**PD Modification Application: PRS 25-0191****Zoning Hearing Master Date:** N/A**BOCC Land Use Meeting Date:** February 11, 2025**Hillsborough  
County Florida****Development Services Department****1.0 APPLICATION SUMMARY****Applicant:** NNP-Southbend II LLC**FLU Category:** Suburban Mixed Use-6 (SMU-6)**Service Area:** Urban**Site Acreage:** 16.41 MOL**Community  
Plan Area:** Apollo Beach, Southshore**Overlay:** None**Introduction Summary:**

The subject vacant property is currently zoned PD 14-0815, as most recently modified by PRS 24-1046 which allows for mixed use. The applicant is proposing to modify the approved site plan as it pertains to the development of Folio 54244.0062 which is within Tract 24A, for the addition of two right-in / right-out access points from 19th Avenue NE and 30th Street as depicted on the site plan submitted with this application. Proposed Development standards for the parcel have also been added. In addition, Retail and Office design standards for Folio 54244.0062 are proposed to be removed.

### 7.2.1 Proposed Site Plan (Full)

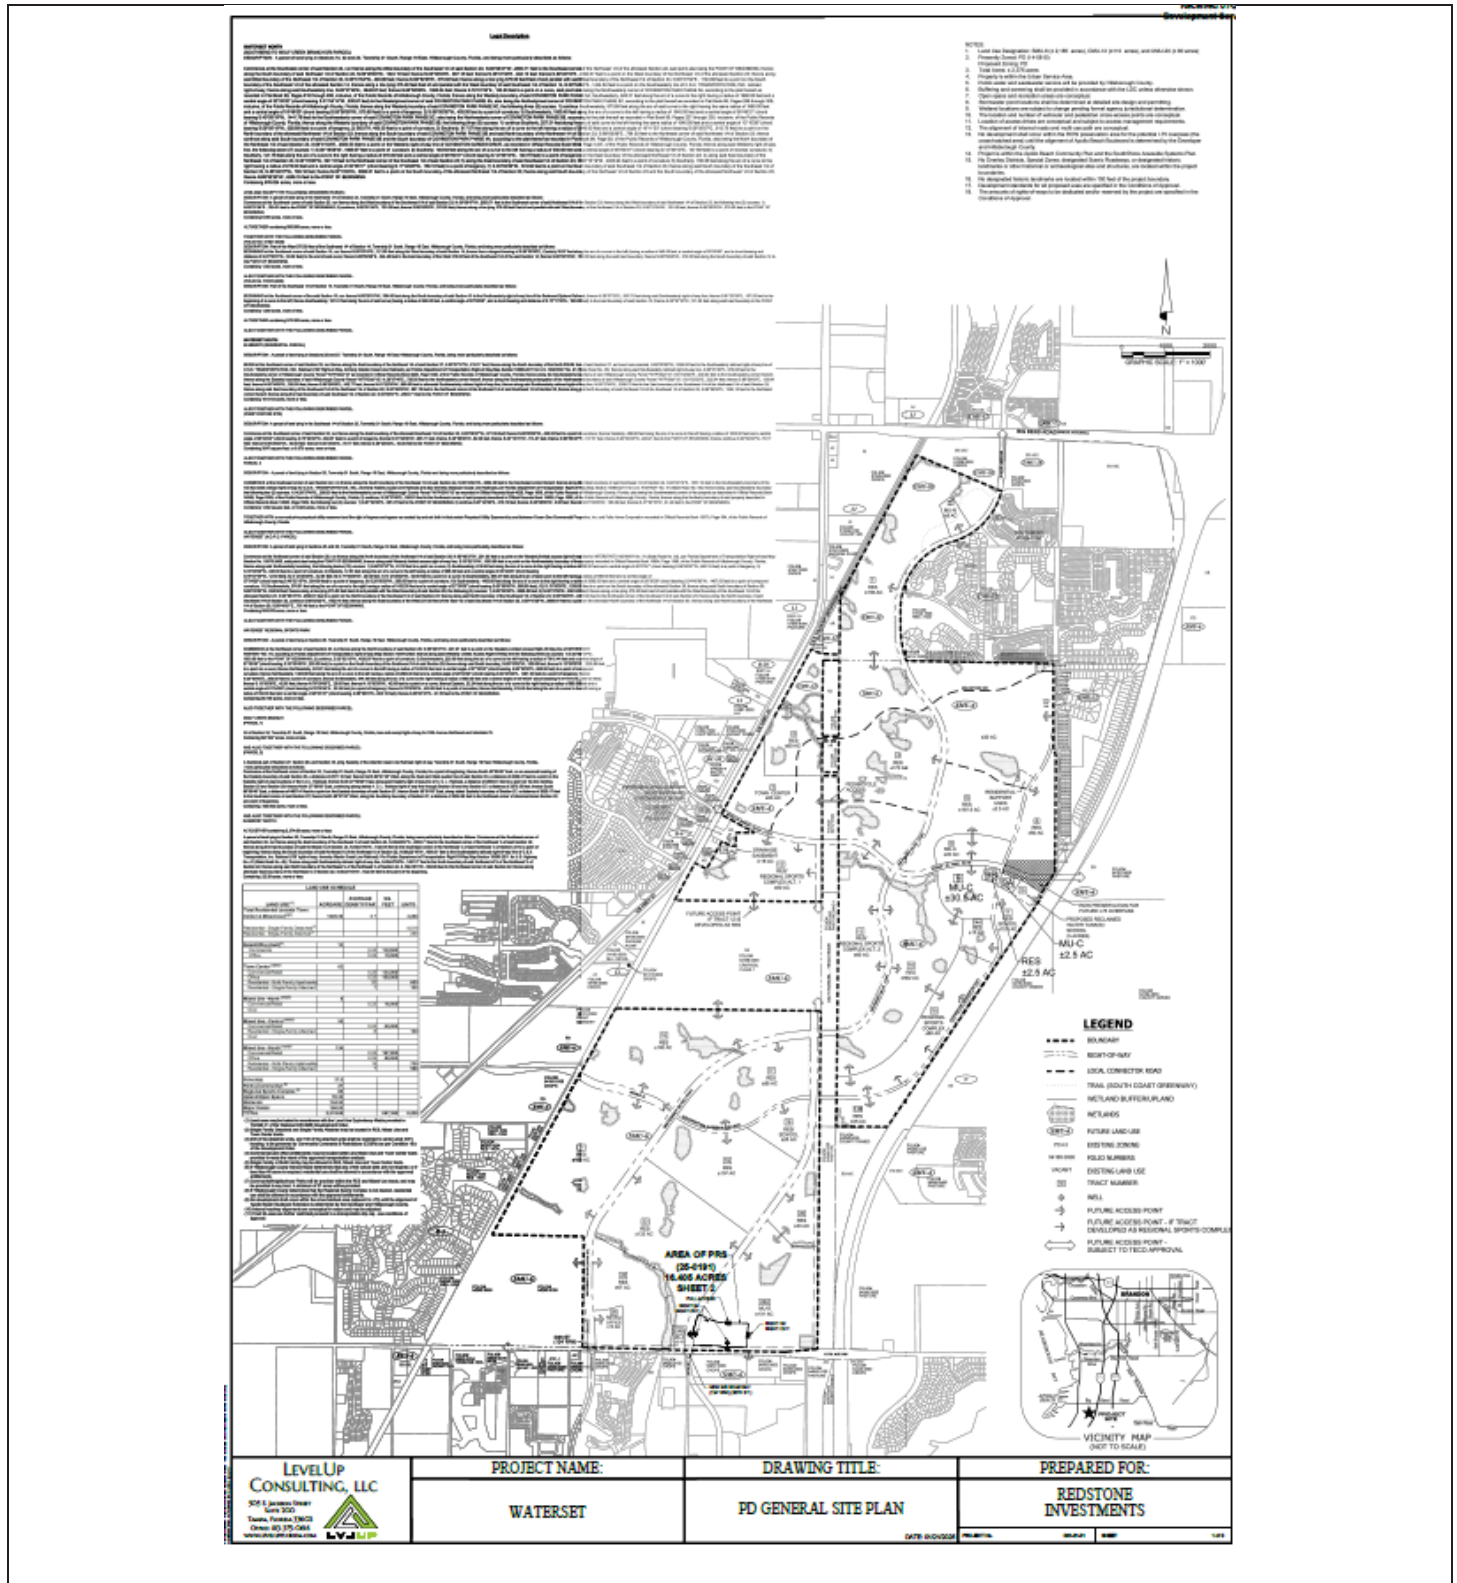
1. Correct sheet number scrivener's error on sheets 1 and 2.
2. Correctly label 19<sup>th</sup> Ave NE on sheet one of two.
3. Display all roadways adjoining, traversing, or within 150ft of the project boundaries on sheet one of two.

4. The developer shall remove the "New Bus Stop Location Per HART" shown on Page 2 of the site plan. Staff notes that location of the two required bus bays shall be determined at the time of plat/site/construction plan review, must be consistent with the locational requirements of zoning condition 54, and that only one of the two required bus bays must be constructed concurrent with development of the Subject Area; and,

### 7.2.2 Proposed Site Plan (Full)

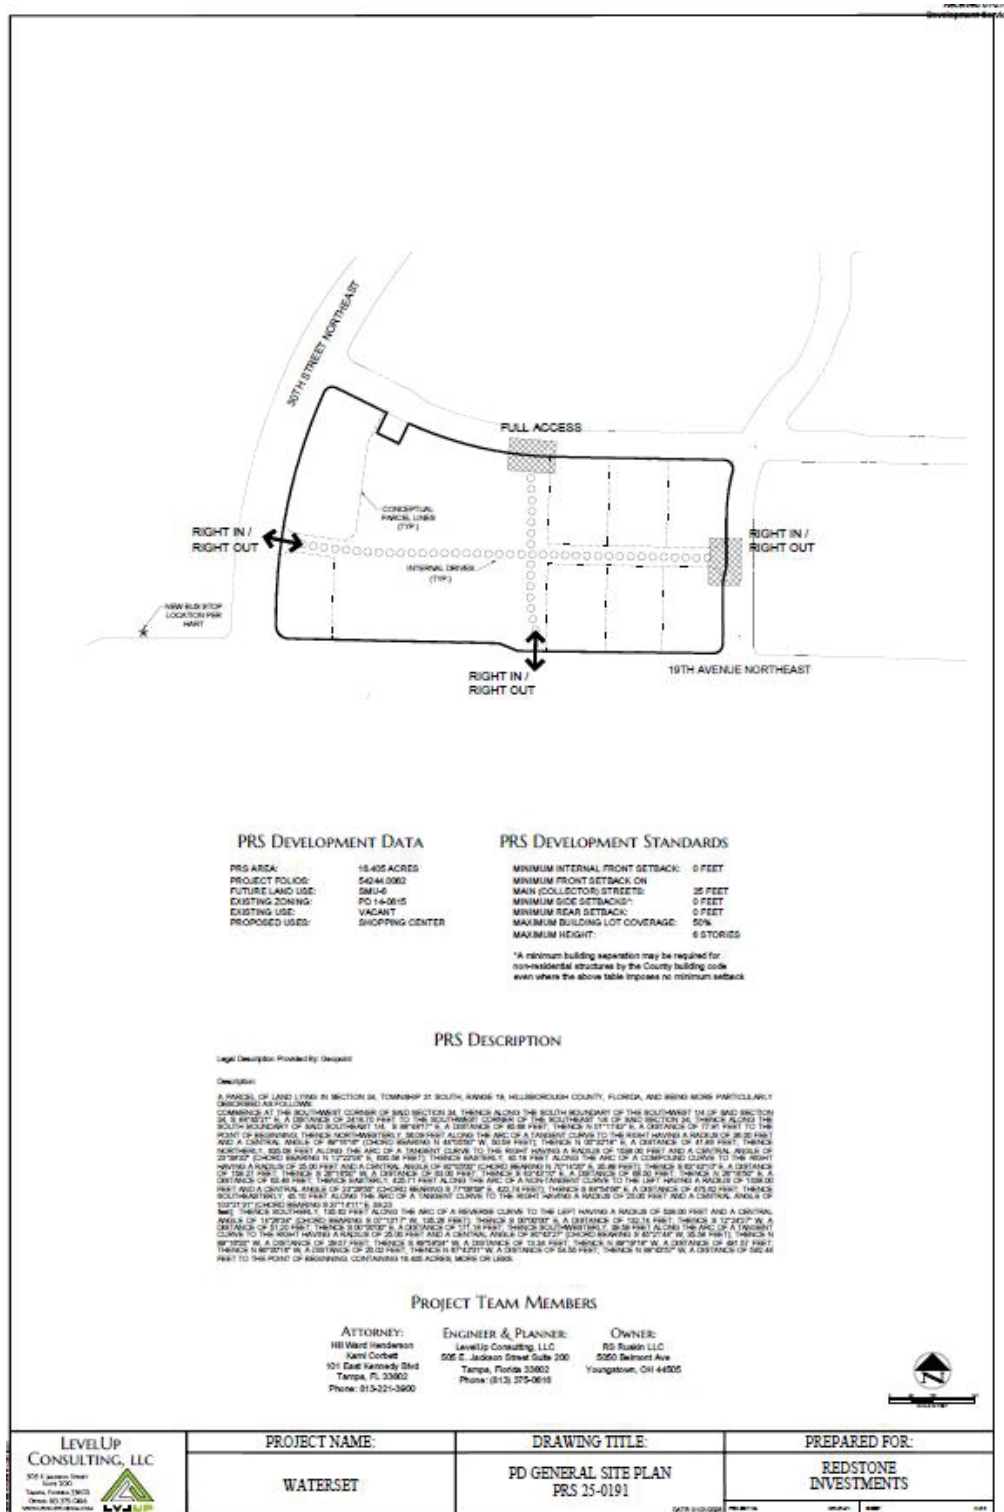
5. Remove comment response letters and other information which should be included within the Certified Site Plan.
6. On sheet two of two, replace the access label on 30th St NE which states "Right-in/Right- out " with a label stating, "Proposed Right-in/Right-out – See Conditions of Approval for Required Site Access Improvements".

7. On sheet two of two, replace the access label on 19th Ave NE which states "Right-in/Right- out " with a label stating, "Proposed Right-in/Right-out – See Conditions of Approval for Required Site Access Improvements".

8. On sheet two of two, replace the access label on the north-south collector roadway located along the eastern boundary of the Subject Area which states "Right-in/Right-out" with a label stating "Proposed Right-In/Right-Out – Site Access Improvements Are to be Determined - See Conditions of Approval"

9. On sheet two of two, replace the access label to the east-west collector roadway located along the northern boundary of the Subject Area which states "Full Access" with a label stating "Proposed Right-In/Right-Out – Site Access Improvements Are to be Determined - See Conditions of Approval"

- Remove comment response letters and other information which should be included within the Certified Site Plan.
- On sheet two of two, replace the access label on 30<sup>th</sup> St NE which states "Right-in/Right-out" with a label stating, "Proposed Right-in/Right-out – See Conditions of Approval for Required Site Access Improvements".

- On sheet two of two, replace the access label on 19<sup>th</sup> Ave NE which states "Right-in/Right-out" with a label stating, "Proposed Right-in/Right-out – See Conditions of Approval for Required Site Access Improvements".

- On sheet two of two, replace the access label on the north-south collector roadway located along the eastern boundary of the Subject Area which states "Right-in/Right-out" with a label stating "Proposed Right-In/Right-Out – Site Access Improvements Are to be Determined - See Conditions of Approval"

- On sheet two of two, replace the access label to the east-west collector roadway located along the northern boundary of the Subject Area which states "Full Access" with a label stating "Proposed Right-In/Right-Out – Site Access Improvements Are to be Determined - See Conditions of Approval"
